REVISION 01

OUR
TOWN
HALL
PROJECT

PROJECT STATUS	RIBA STAGE 5
CLIENT	MANCHESTER CITY COUNCIL
PROJECT	OUR TOWN HALL
DRAWING TITLE	Rooflight WCR01 Existing and Proposed Rooflight Elevations
SIZE & SCALE	A1: Scale as Stated
DRAWING STATUS	ISSUED FOR CONSTRUCTION
JOB NUMBER	236959

2 **ELEVATION X-X AS PROPOSED**
7486 1:20

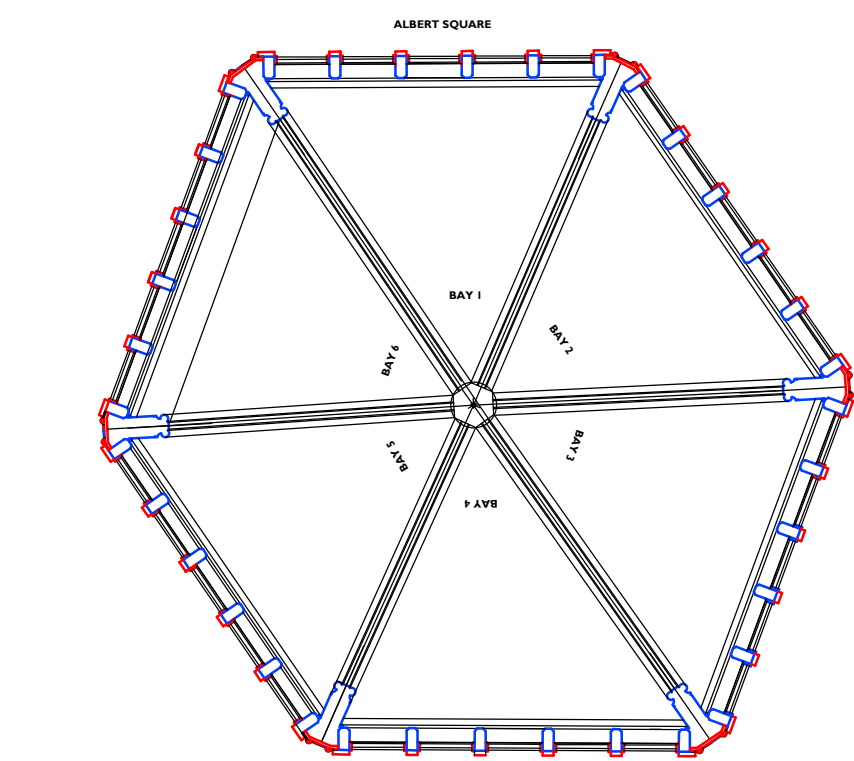
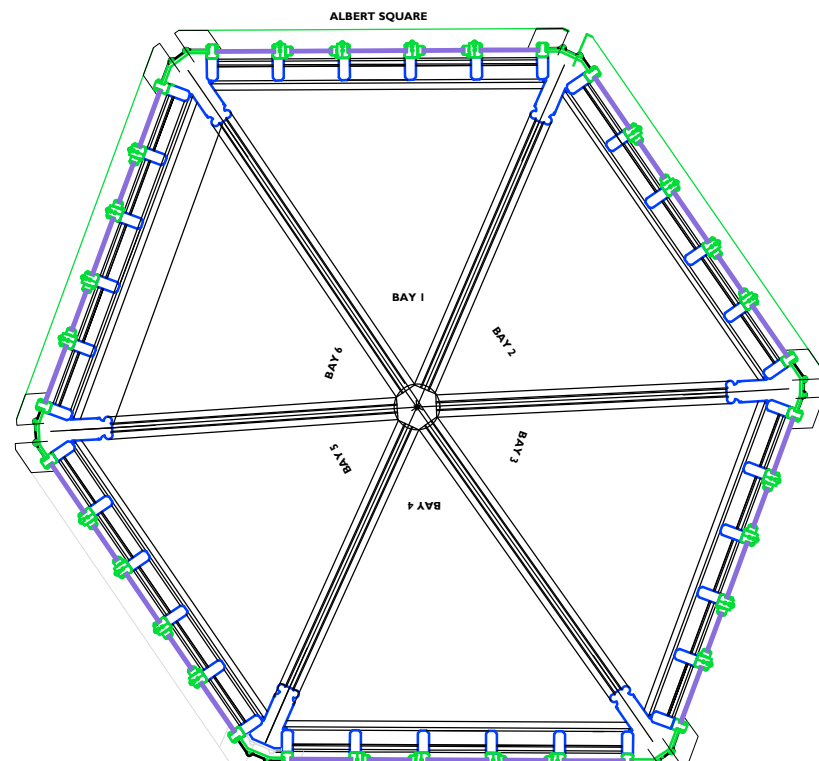
Windows reduced in height and cill projection increased.
Kerb upstand ventilation detail amended and notional lead gutter height added. Alunim perimeter cappings changed to lead
